PRODUCT CHANGE NOTIFICATION

Bourns® PEC11J Series 12 mm SMD Long Life Encoder

Solderability Change

SC2620

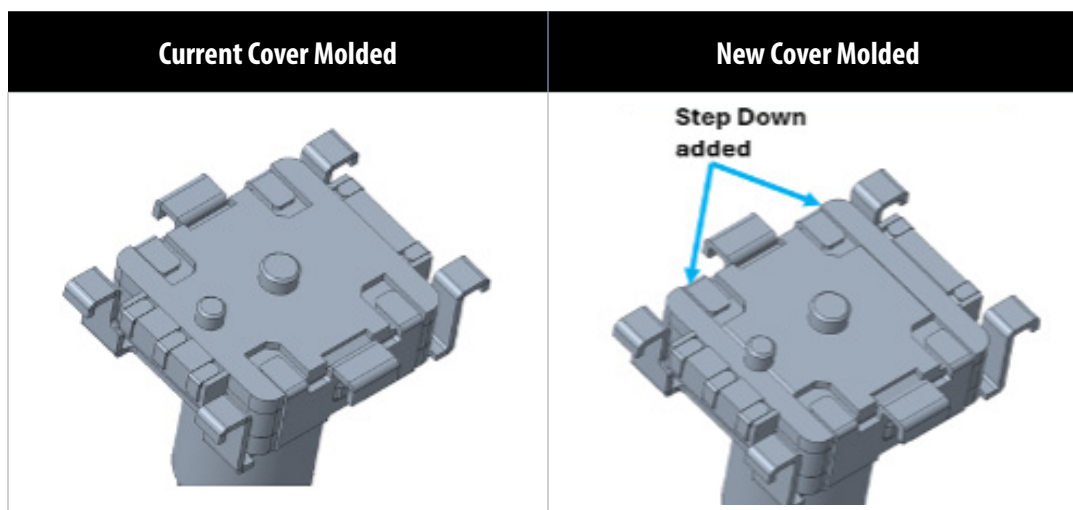
Riverside, California – June 15, 2026 – Effective June 30, 2026, Bourns will modify the molded cover of the PEC11J Series 12 mm SMD Long Life Encoder to improve solder process reliability. The modification adds a step-down feature to the sides of the cover that prevents solder from flowing to the terminals during reflow when the bracket is installed.

The form, fit, function, quality, and reliability of the PEC11J Series remain unchanged as a result of this modification. All specifications remain unchanged. Qualification testing has been performed against all specifications, and reliability data is available upon request. Samples are also available upon request. Bourns recommends that customers verify satisfactory performance of the affected part numbers in their specific applications. For questions or additional information, contact Customer Service/Inside Sales.
